TO: Mercedes-Benz Dealer Principals, General Managers, Sales Managers, Service Managers, Parts Managers	FROM: Gregory Gunther, Department Manager, Vehicle Compliance and Analysis, Engineering Services
RE: Recall Campaign Launch Notification Check Sliding Roof Bonding – Phase 1 MY06-07 Various Models	DATE: June 29, 2020

Campaign No. 2020040011, June 2020

SUBJECT: **Models C-Class, CLK-Class, E-Class, and CLS-Class (203, 209, 211, and 219 platform)**
Model Years 2006-2007
Sliding Roof Bonding - Phase 1

Order No. P-RC-2020040011

Figure 2

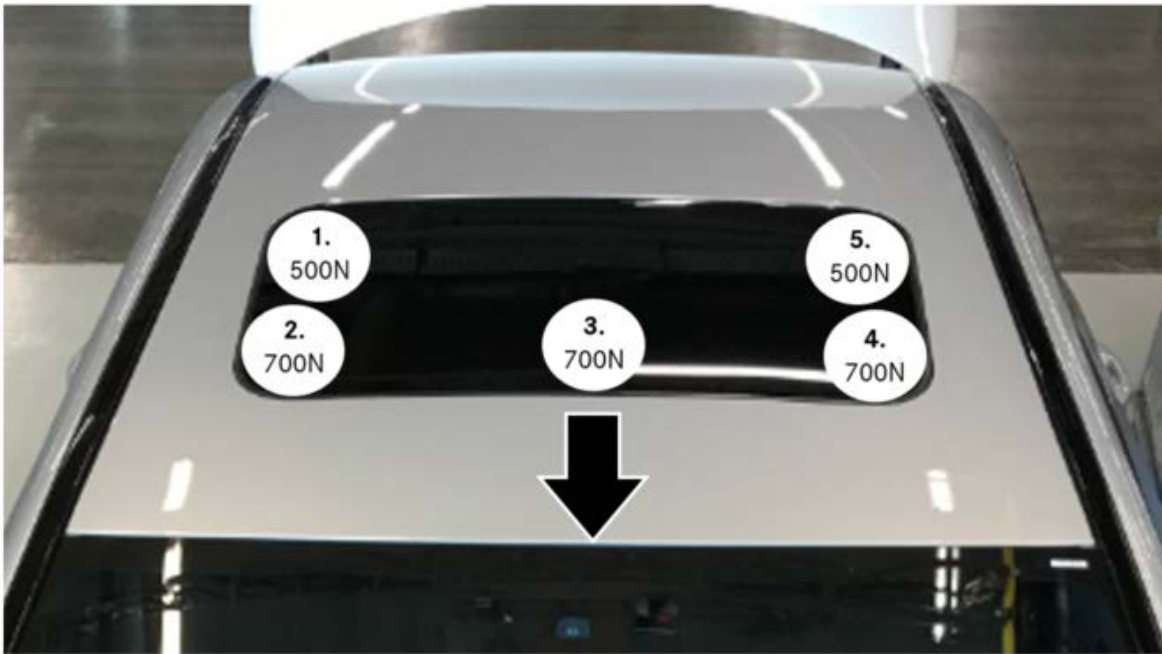
3. Position cup suction tool (figure 2) and pull as **vertically** as possible (tolerance of ± 10 degrees) using lifting tool.

Specified force 500 N/700 N (figure 3).

Figure 3 (test sequence 1, 2, 3, 4, 5 – arrow specifies front of vehicle)

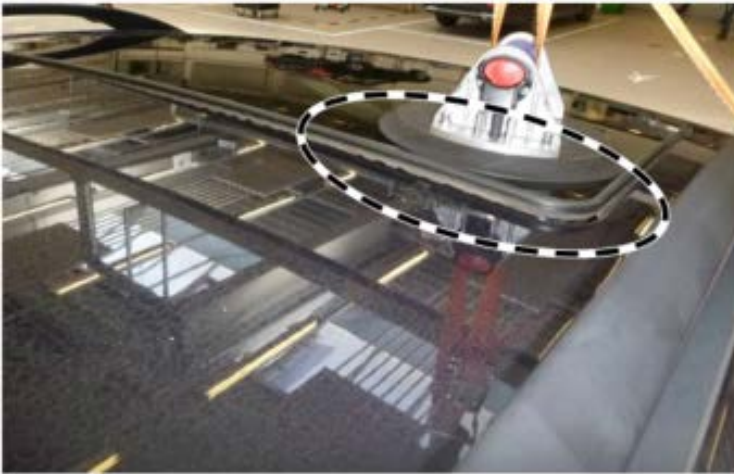
No "hold function" may be activated so that the current pulling force is always displayed.  Position cup suction at 5 positions in the sequence **1, 2, 3, 4, 5: (Figure 3).**

The specified force must be monitored during the first minute and adjusted if necessary (tolerance ± 10 N). **The specified force must not be exceeded.** Pull as vertically as possible (tolerance ± 10 degrees) at the specified force. There must not be a person inside the vehicle during the check, and the vehicle must not be touched if possible.

The holding time per position must be exactly **10 min.**

Figure 5 (**NOT OK**)

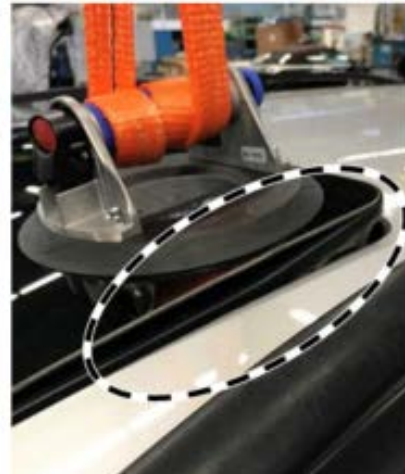
- i** The sliding roof panel is lifted out of the roof frame noticeably at the rear test positions 1 and 5 (**figure 4**).
- i** If the sliding roof panel detaches from the padding of the tilting/sliding roof frame at one of the test positions (see **figure 5**), the sliding roof panel must be replaced.

- C.** If the sliding roof panel detaches from the padding: Carry out **work procedure**.
- D.** If the sliding roof panel does **not** detach from the padding: **End measure**.
